ANADROMOUS WATERS CATALOG/ATLAS
CORRECTION FORM

Describe Change(s): Changes involve corrections to annotation where fish species codes are missing or AWC# is in error

Nomination Number: CB-368

From: Barnhill, Carol A (DFG)
Sent: Friday, February 13, 2009 6:19 PM
To: Johnson, J D (DFG)
Subject: AWC species errors

247-41-10200-2053-3219
11
12
Hewitt
Lake
Sr
200
200
14
13
COp,Sp
Ssr
13
18
18
Ssr
Ss
Mist
Lake
Ssr
Ssr
19
Cabin
Hewitt
135
SR TAT A-3 Tyonek 0-4 SRS
247-41-10200-2053-
3213-4050-0010
Lake 2 SSR
Lake 1 SR
C-8

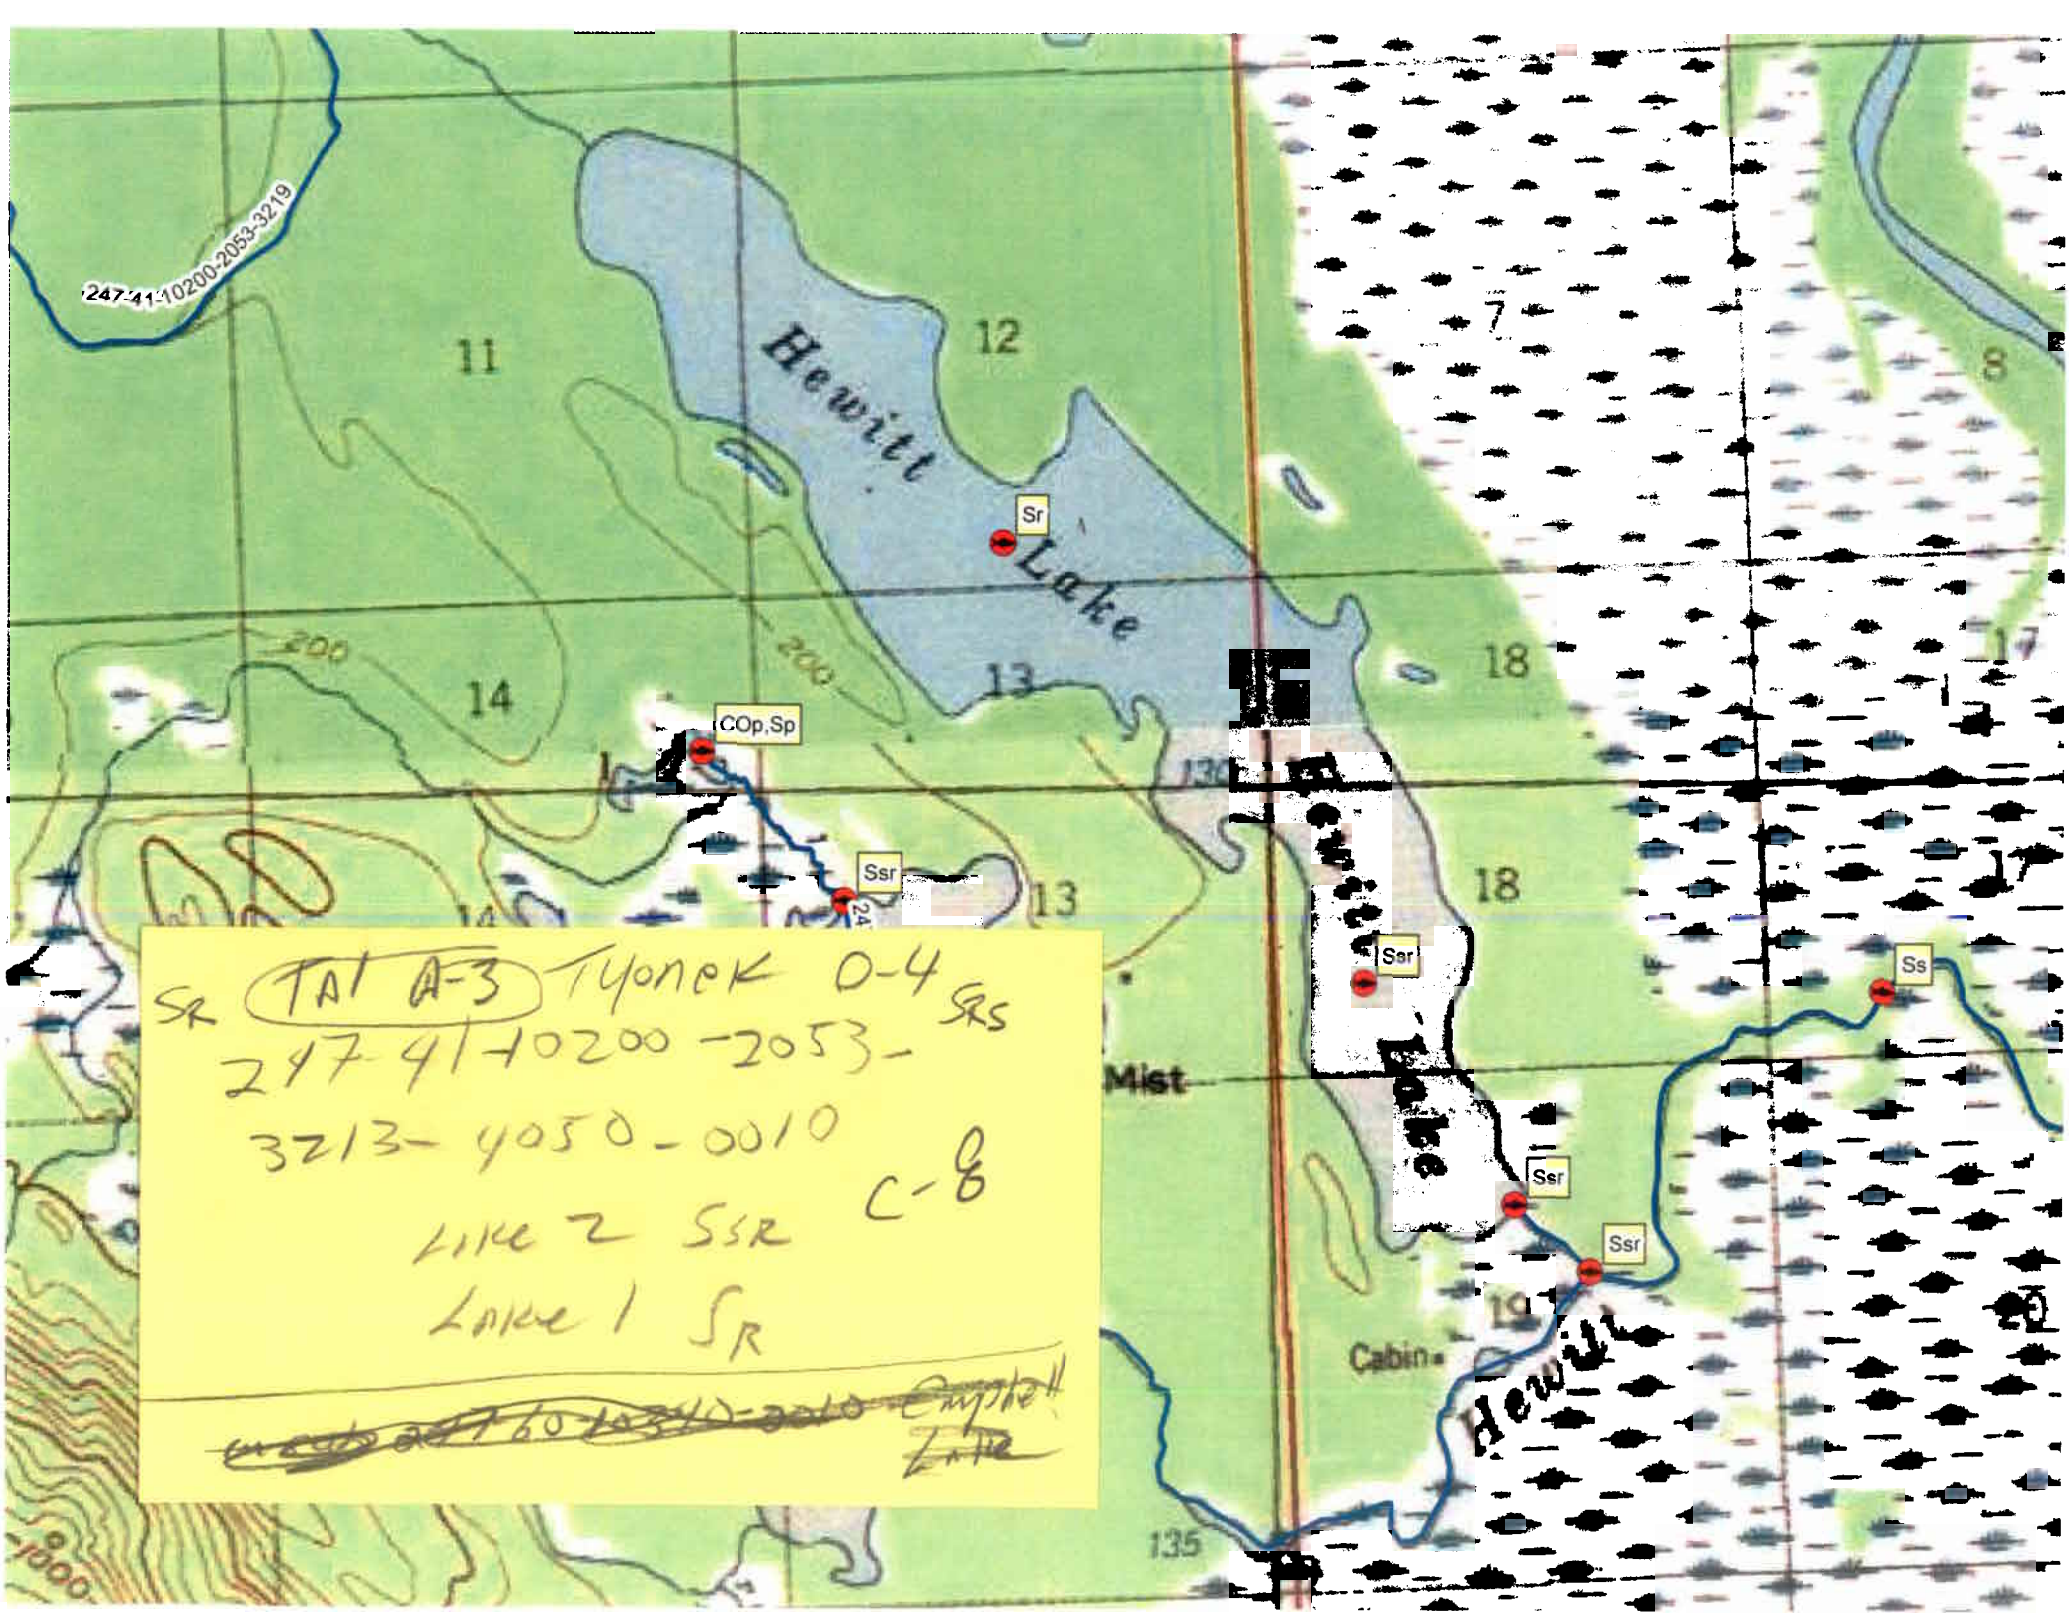
AWC#	Atlas map	Error on map	Corrective action
200-20-10110-2031-3032-4040-5015	Cordova B-1	No S in -5015	Add sockeye salmon to water body
200-20-10110-2031-3055	Cordova B-1	No DV in -3055	Add Dolly Varden to water body
221-10-10160-2150-3165	CORDOVA D-5	AWC # in error	Renumber as 221-10-10160-2051-3165
221-10-10160-2150-3175	CORDOVA D-5	AWC # in error	Renumber as 221-10-10160-2051-3175
221-10-10160-2150-3185	CORDOVA D-5	AWC # in error	Renumber as 221-10-10160-2051-3185
244-20-10090-2030	Kenai A-5	No DV at mouth of -2030	Add Dolly Varden to water body
244-20-10100-2019	Kenai A-5	No DV in -2019	Add Dolly Varden to water body
247-41-10200-2300-3011	Talkeetna A-1	No K in -3011	Add Chinook salmon to water body
247-41-10200-2053-3170-4027	Talkeetna A-2	No CO in -4027	Add coho salmon to water body
247-41-10200-2053-3170-4027	Talkeetna A-3	No CO in -4027	Add coho salmon to water body
247-41-10200-2053-3213-4050-0010	Talkeetna A-3	No Ss in -0010 (lake 1 pt)	Add sockeye salmon spawning to water body

244-20-10090
NINILCHIK
ROAD
Ninilchik
Landing Strip
Kp
COs,Ks COr,Kp
Pp
DVr
244-20-10100-2019
COs,Ks,Pp
Creek
244-20-10100
Deep
Creek
244-20-10100-2019-3018
DVr
DVr
12
7
8
9
10
13
18
17
16
15
14
13
18
17
16
15
24
19
20
21
22
23
257x
280x
434x
574x
218x
429
400

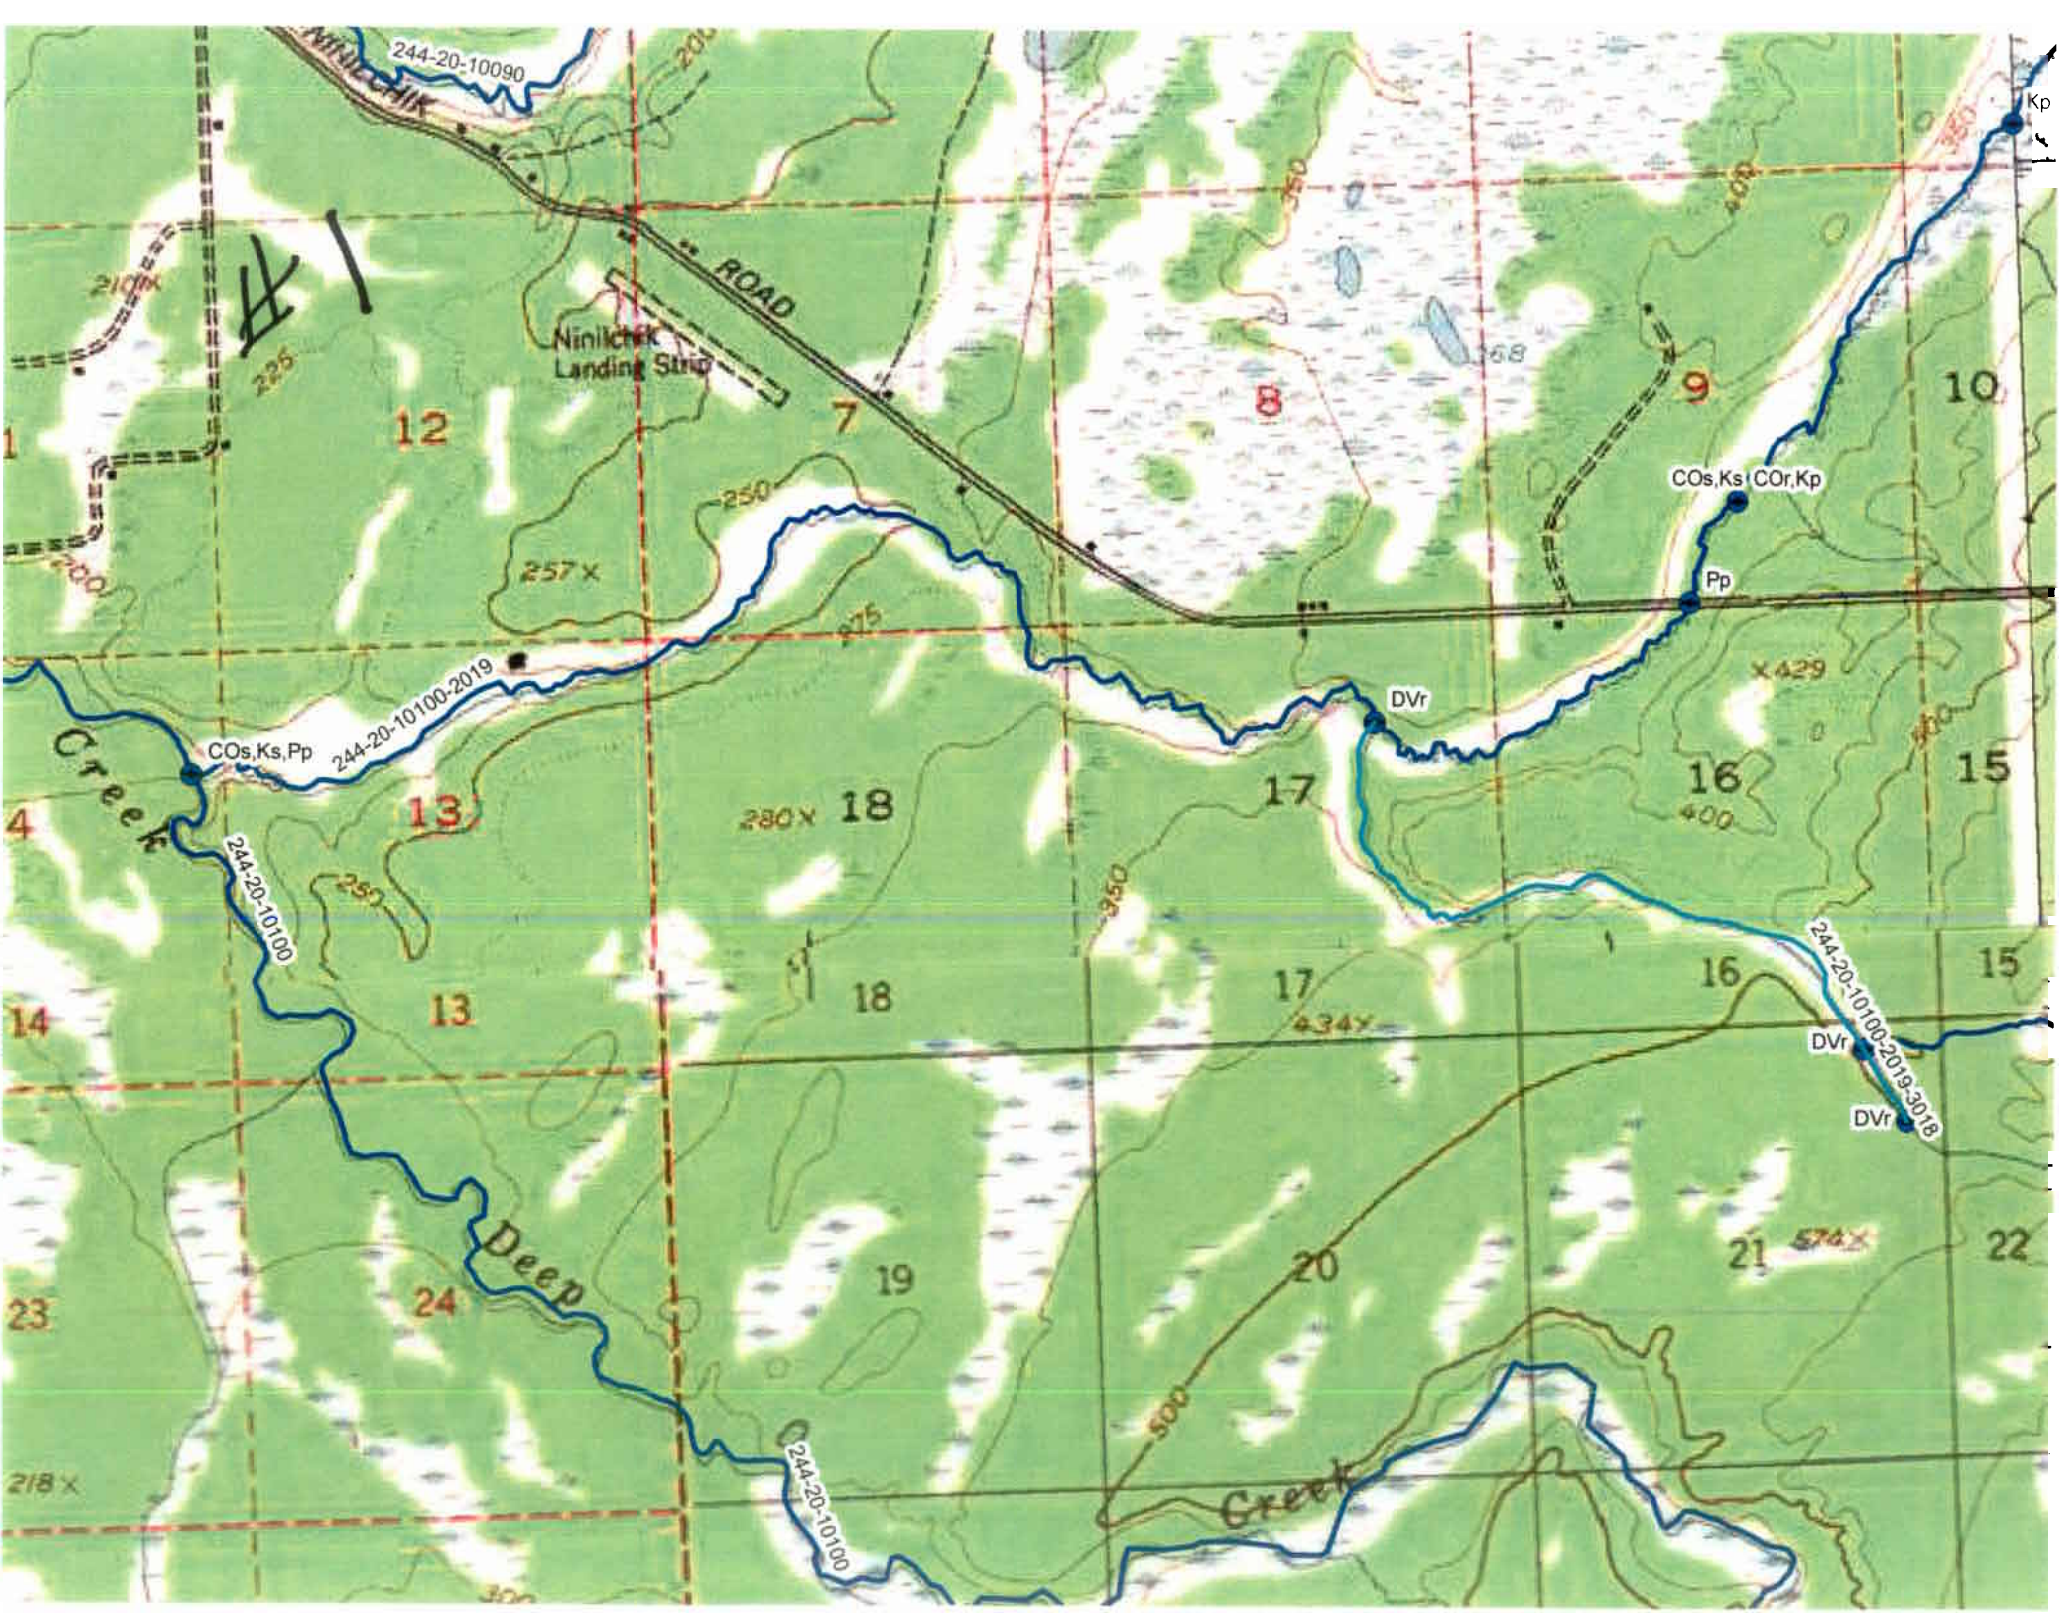
1	244-20-10100-2019-3018	Kenai A-5	No DV in -2019
2	244-20-10090-2030-3032	Kenai A-5, A-4	No DV at mouth of -2030
3	200-20-10110-2031-3055-4019	Cordova B-1	No DV in -3055
4	247-10-10080-2010-3040-4010-5002	Tyonek A-6 & A-5	No CO in -4010
5	247-41-10200-2053-3229-4009-5105	Talkeetna A-4	No CO in -4009 (Also fix stream number in upper right map)
6	247-41-10200-2053-3170-4027-5033	Talkeetna A-2 & A-3	No CO in -4027
7	247-41-10200-2300-3011-4008	Talkeetna A-1	No K in -3011 (or 2300)
8	247-41-10200-2370-3041-4010	Talkeetna B-1	No S in -3041

COPDUP
Blueline
500
COr
COr
25
30
29
06-291
400
COPDUP
500
06-291
CCRDUR
CCRDUR
500
x699
36
31
32
Add new Stream 244-20-10090-2030-3032 w/DUPCCGP
Add new Stream 244-20-10090-2030-3032-4005 w/DUPCCGP

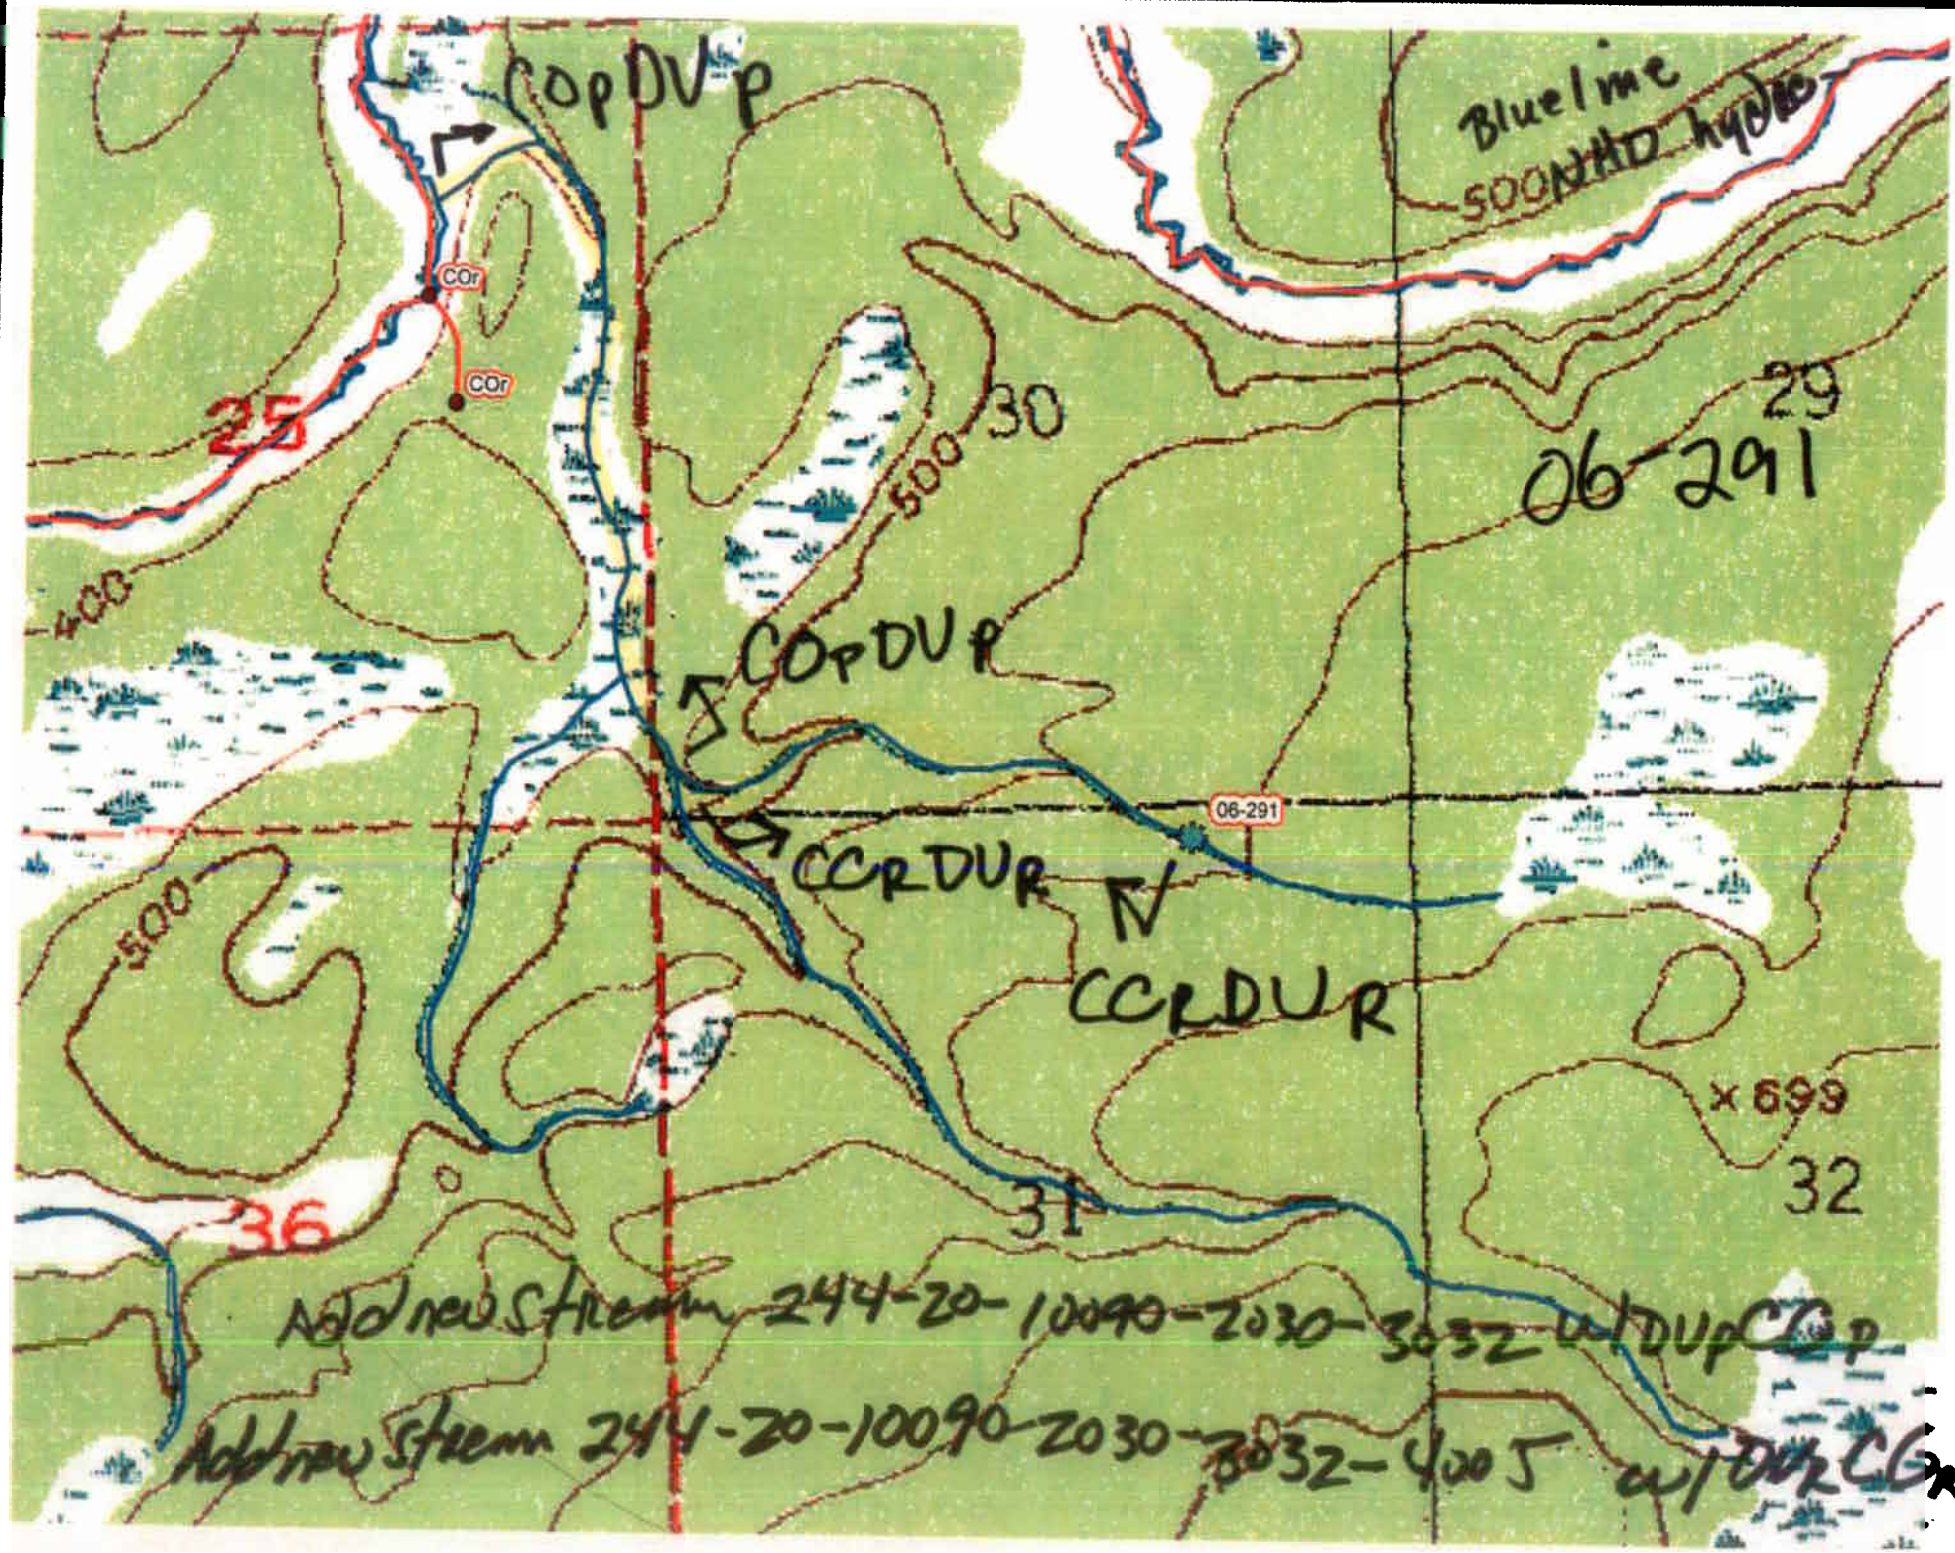
See attached photos and map. Add new stream 244-20-10090-2030-3032-4005 w/ Coho salmon and Dolly Varden rearing

Add new stream 244-20-10090-2030-3032 w/ Dolly Varden, Coho Salmon present
